2 October 2025

RE: SSDSSD-83431958 Residential development with infill affordable housing- 16-20 Middle Harbour Road, Lindfield – 98 Apartments incl 19 Affordable units

Source: Martens Flood Report

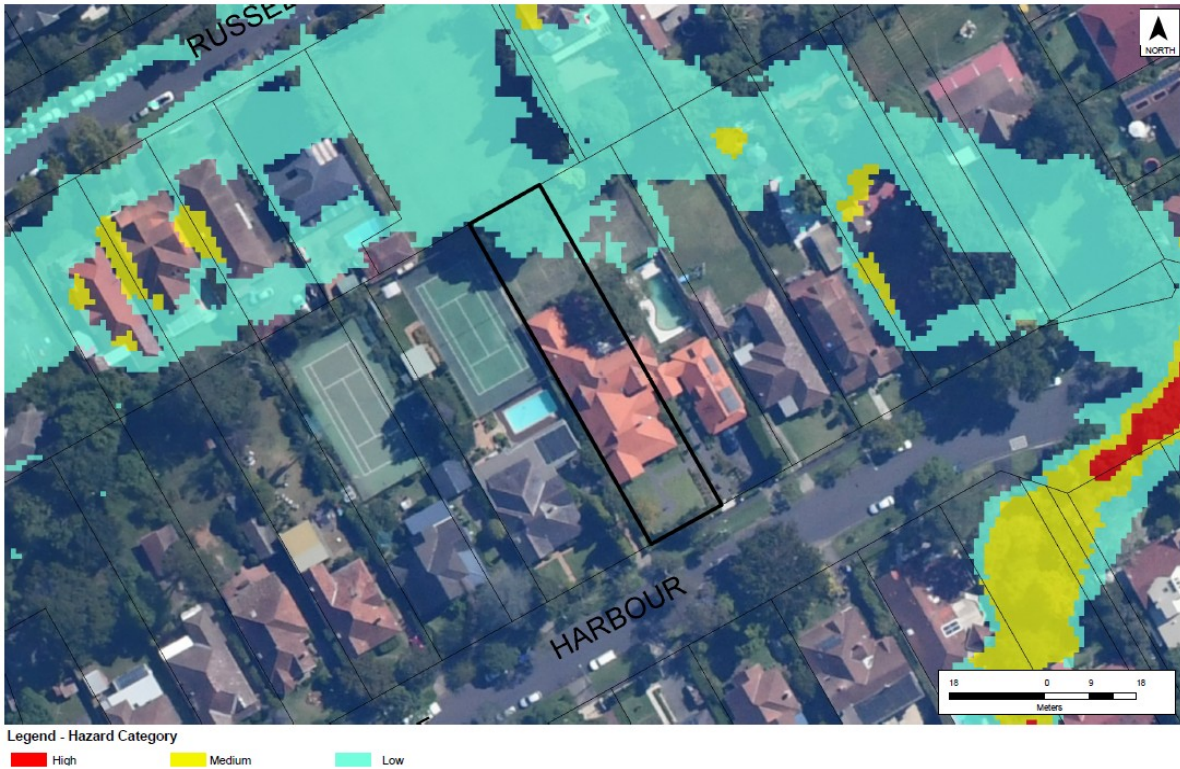
- The site is identified as being affected by an overland flow path in the north-eastern corner of No. 18-20 Middle Harbour Road.
- Based on the modelling results under existing conditions, floodwaters overtop Russell Avenue and flow across 22 Middle Harbour Road, entering the site along its northern boundary. **This is a statement in error as it cannot flow across 22 Middle Harbour Road and then enter the site. It must enter the site across 16-20 Middle Harbour Road.**

- The flows then continue along the drainage depression at the rear of the site in a north easterly direction, ultimately discharging onto 22 Middle Harbour Road.

- The Martens Report states 'The existing conditions at the site were found to show areas of high, medium, and low flood hazard on the site. The site experiences significant inundation during the 1% AEP and PMF events.'

- The PMF (Probable Maximum Flood) event results in increased overtopping and a broader flood extent at the rear of the site compared to the 1% AEP event.

Figure 17: Detail, heritage map showing heritage items and Conservation Areas in relation to the subject site. The site is outlined in black and shaded dark blue.

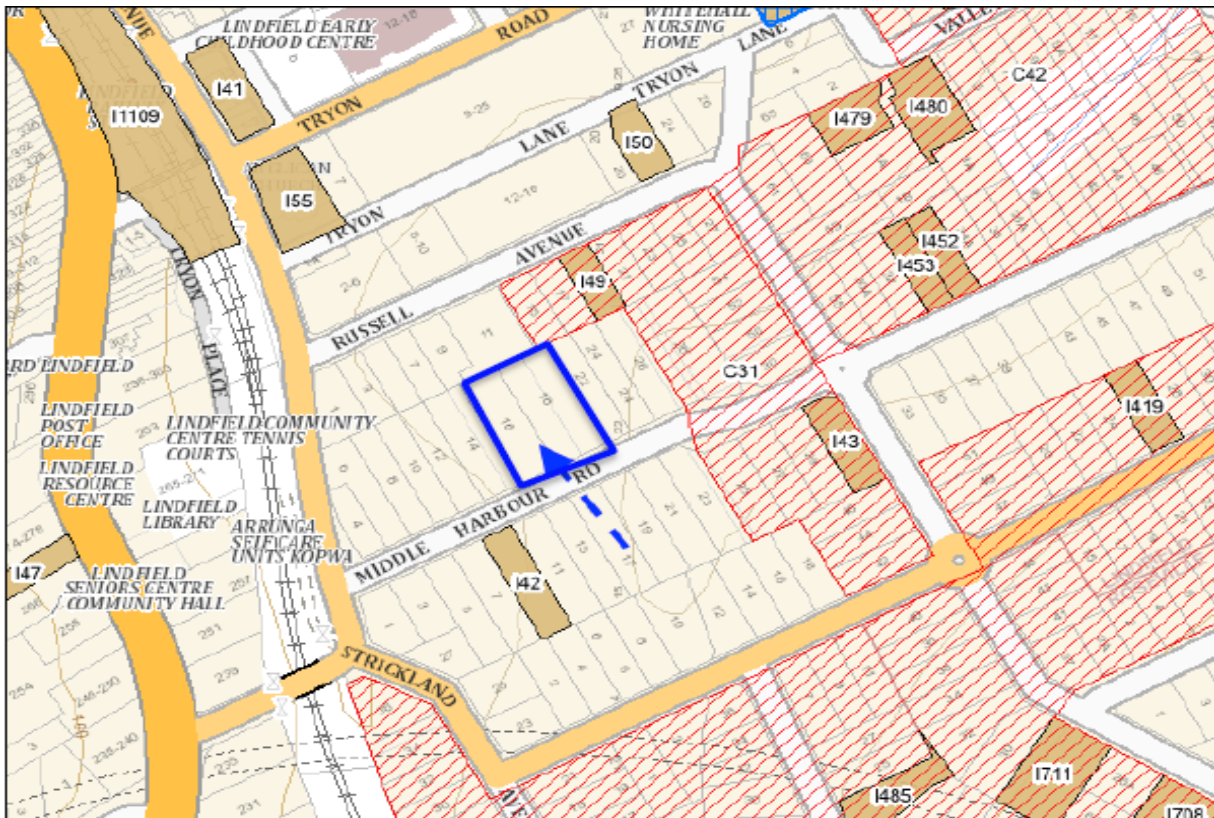
The Heritage report also states that due to the height of the development, it will be visible from the Clanville Avenue HCA as well as the Heritage item at 34 Middle Harbour Road.

It is understated in the HIA report paid for by the proponent, but it is clear that this development will have a major detrimental impact on the heritage of the area, its heritage items and the integrity of the HCAs and should be rejected.
